SAN FRANCISCO SOUTHERN WATERFRONT

Final Supplemental Environmental Impact Report

Planning Department Case No. 1999.377E
State Clearinghouse No. 94123007

Figure 1
Project Area

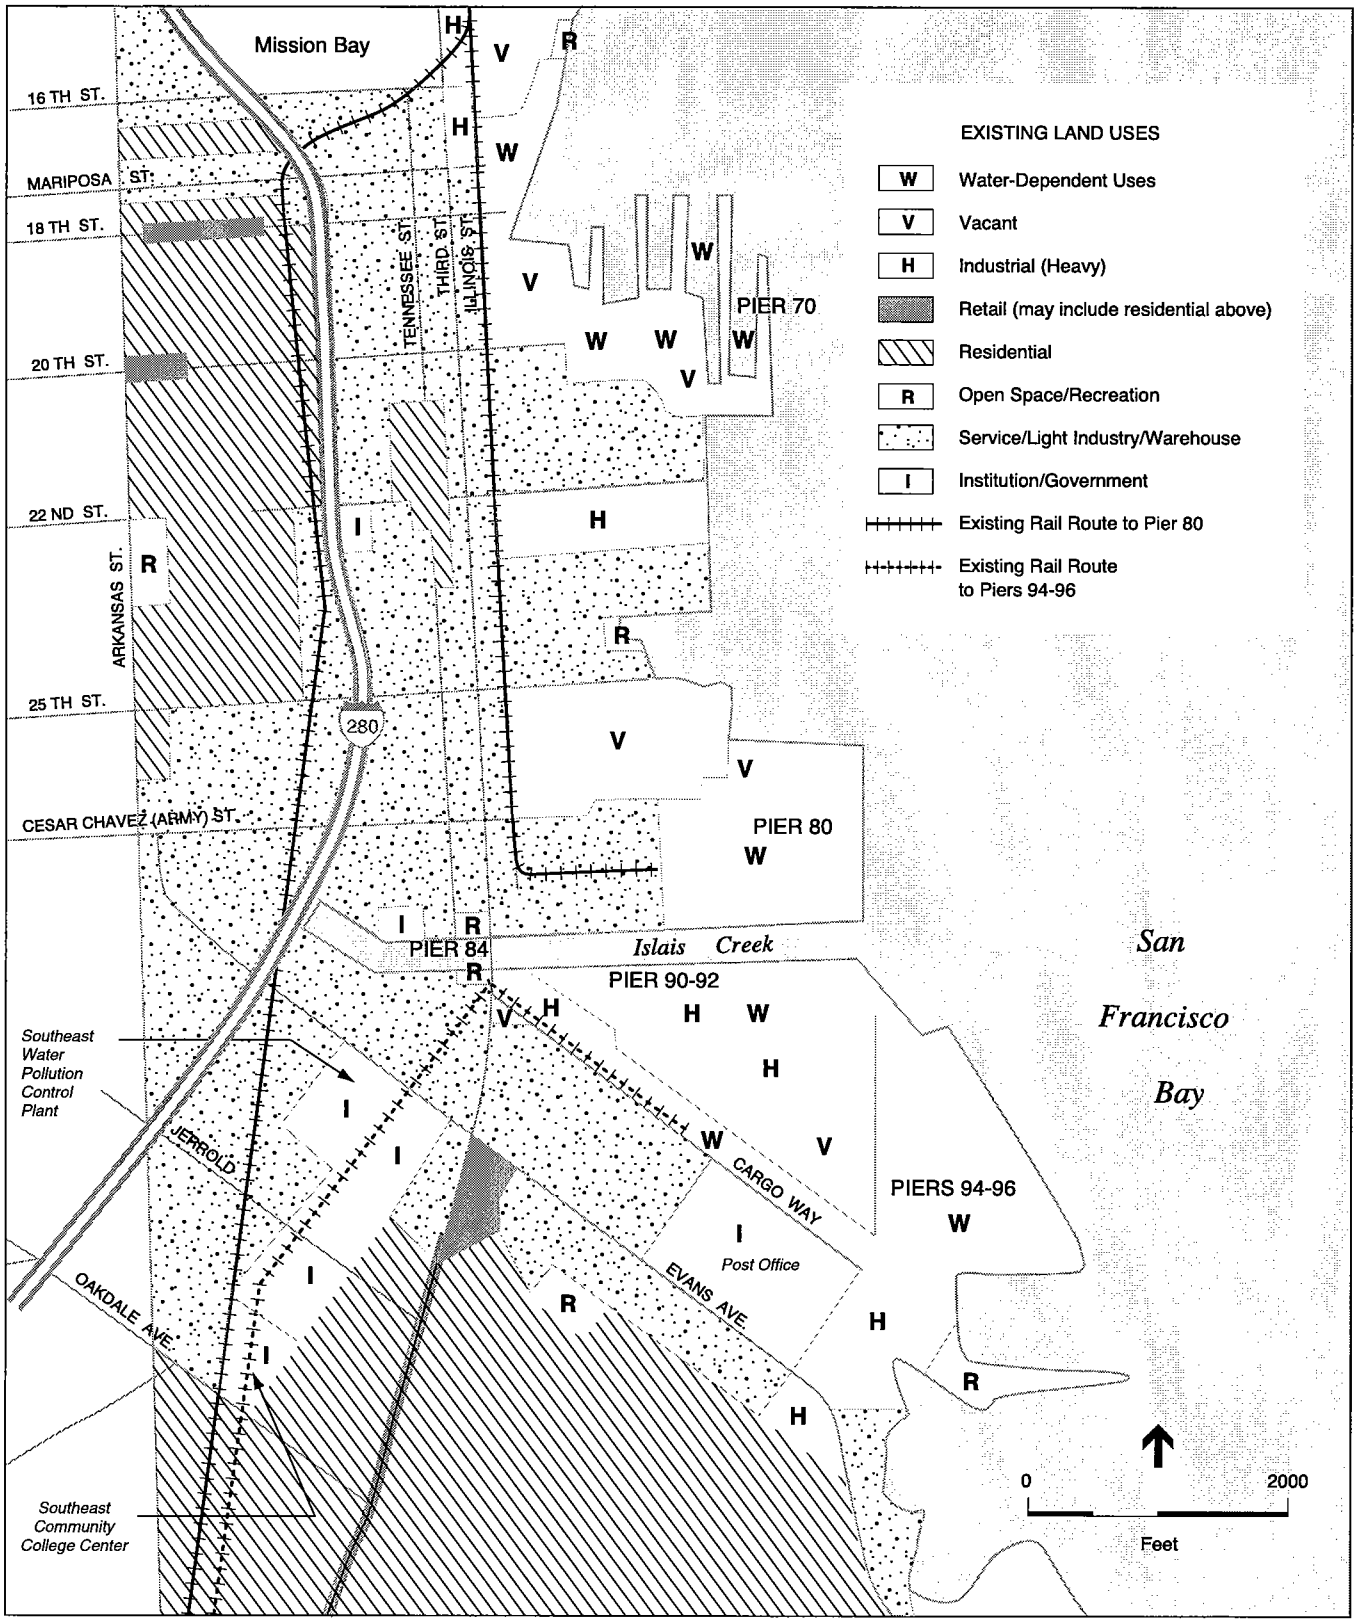
1) The "environmental setting" is incomplete without a map showing the existing uses adjacent to or near the proposed projects. Cumulative impacts cannot be assessed without knowing the locations and activities of large-scale operations already occurring in the area. Specifically, the "Project Components" diagram (Figure 2, page 8) should show the boundaries of the site east of Pier 92 that is currently leased to a sand and gravel operation.

Features such as seawall lots and existing land uses, were not shown on SEIR Figures 1 and 2 to avoid presenting so much information as to make the maps unclear. A generalized map of existing land uses is presented in SEIR Figure 4, SEIR p. 26, and provides sufficient information to evaluate proposed land uses in context.
